BID ADDENDUM #3

REVISED ROOF PLAN (DRAWING A251)

ARDEN HILL - MAIN BUILDING ALTERATIONS TO NORTH WING

Job No.
2023-1011

41 REVISED EQUIPMENT CURB
SCALE: 0 1 2 4 8

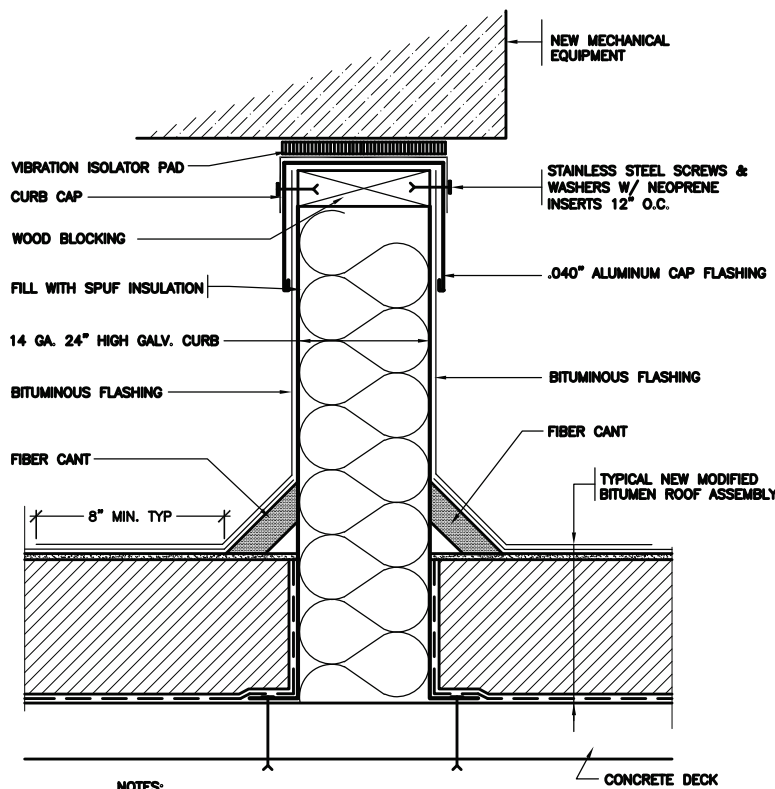
NOTES:
1. NEW 24" HIGH CURBS FOR EQUIPMENT BY MECHANICAL CONTRACTOR.

43 DUCT WATERPROOFING (REVISED DETAIL: 7/A831)
NOT TO SCALE

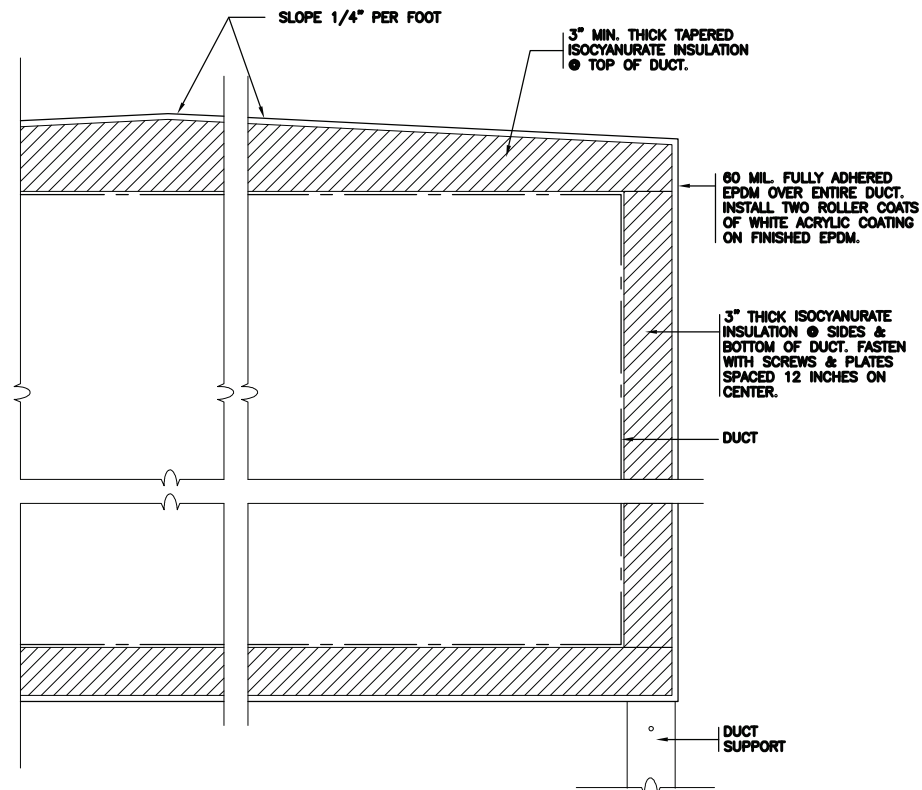
NOTES:
1. COVER FASTENER HOLES AND SEAMS IN THE DUCT WITH PEEL AND STICK MEMBRANE. INSTALL NEW 3" THICK ISOCYANURATE INSULATION ON THE SIDES AND BOTTOM OF THE DUCTS, AND TAPERED INSULATION SLOPING 1/4" PER FOOT, MINIMUM 3" THICK ON TOP OF THE DUCTS. COVER THE INSULATION WITH 60 MIL FULLY ADHERED EPDM.
